City of Mississauga Department Comments

File(s): A175.22 Ward 5

The applicant requests the Committee to approve a minor variance to allow an existing rear deck, balcony and shed with:

Property Address: 5461 Red Brush Dr

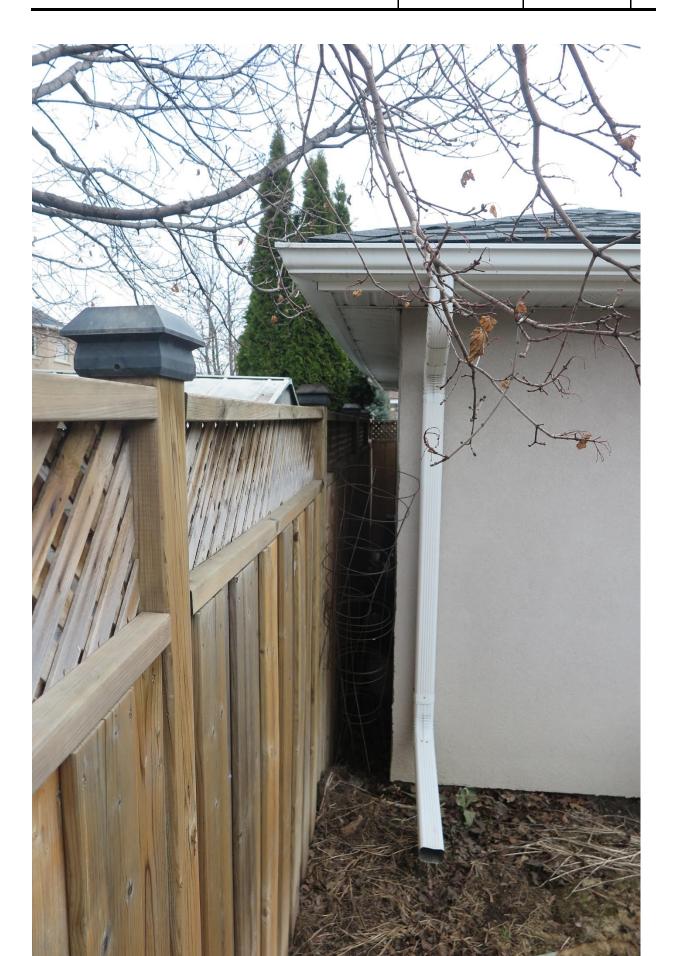
Enclosed for Committee's reference are photos which depict both the fireplace structure (variance#8) and the existing shed. We note that the Grading Plan approved for this property, Lot# 92 Plan 43M-1243 (Grading Plan C-33389 prepared by Adamson Lawson Surbray Associates Ltd) indicates that the drainage from the rear yard was designed to be directed to the existing catch basin on the abutting property to the north (Lot# 91).

The applicant has altered the approved drainage pattern by constructing a shed and garden area where a drainage swale across the rear property line and side yard in the area of the shed was to be constructed. Although the drainage pattern has been altered on this property, we cannot confirm if this has had an impact on the abutting properties as the grading plan depicts that their drainage pattern is independent of this property. In general, adequate setbacks should be provided to accessory structures, in this instance 0.61M to ensure that approved drainage patterns are not impacted, however, in this instance the applicant has provided minimal if any setbacks.

With regards to the variance for the eaves overhang, we question if variance #6 should also reflect a 0.0m setback as opposed to 0.11M as from our site inspection the eaves appear to be encroaching over the fence, although only a proper survey plan can confirm same.
